Re: St. Lucie Plant Unit 2
Docket No. 50-389
Renewed Facility Operating License No. NPF-16

Response to NRC Reactor Systems Branch Request for Additional Information
Regarding Extended Power Uprate License Amendment Request

Response to NRC Reactor Systems Branch
Request for Additional Information

Severed SI Line
CORE POWER vs TIME

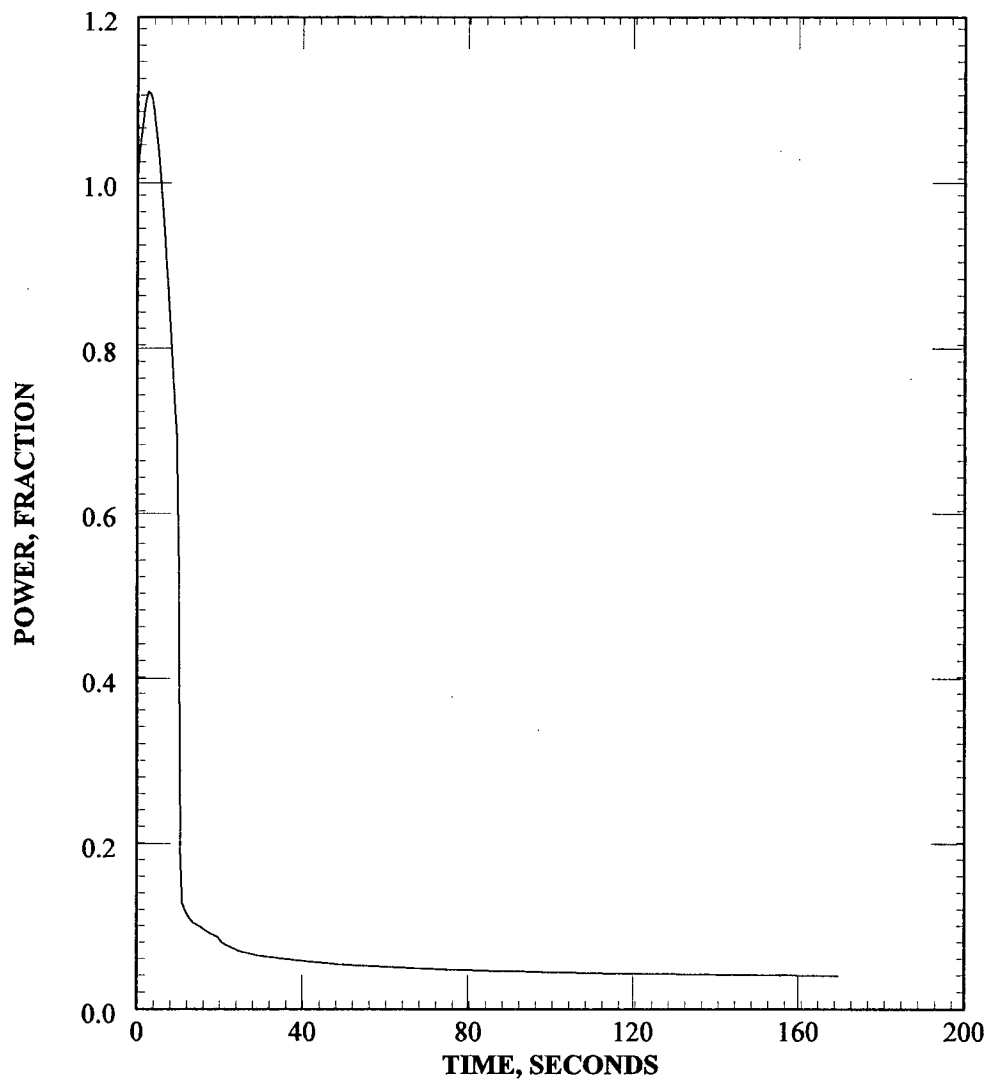
The response to RAI SRXB-89 was incomplete. The severed injection line break has some significant differences from the other small breaks and therefore cannot be included in the assumptions about small break sizes greater than $0.06 \text{ ft}^2/\text{PO}$. The SIT break will depressurize faster and the accumulators will cut in faster than with smaller breaks, but the SIT injection and SI pump spillage is unquantified, and the treatment of ECC bypass is not addressed. A large amount of the SIT flow that enters the downcomer may also go out the break. Please provide the results of the broken injection line break. If the SBLOCA methodology is not appropriate please provide an analysis using a different method.

A severed Safety Injection (SI) line break of 0.5592 ft^2 was explicitly analyzed for St. Lucie Unit 2 at Extended Power Uprate (EPU) conditions using the NRC accepted Appendix K Small Break Loss-of-Coolant Accident (SBLOCA) Analysis methodology. This methodology is consistent with that used in the SBLOCA reported in the St. Lucie Unit 2 EPU Licensing Amendment Report. Conservatively the analysis did not credit the SI pump delivery flow to the intact cold legs by assuming 100% flow diversion of the SI pump flow to the broken SI line. A limiting resultant PCT of 1347°F was attained which is bounded by the reported PCT for both SBLOCA and LBLOCA EPU analyses.

The PCT results for the analysis are given in Table 1. The sequence of events/Times of interest table is provided in Table 2. Plots for the following parameters are provided in Figures 1 through 4.
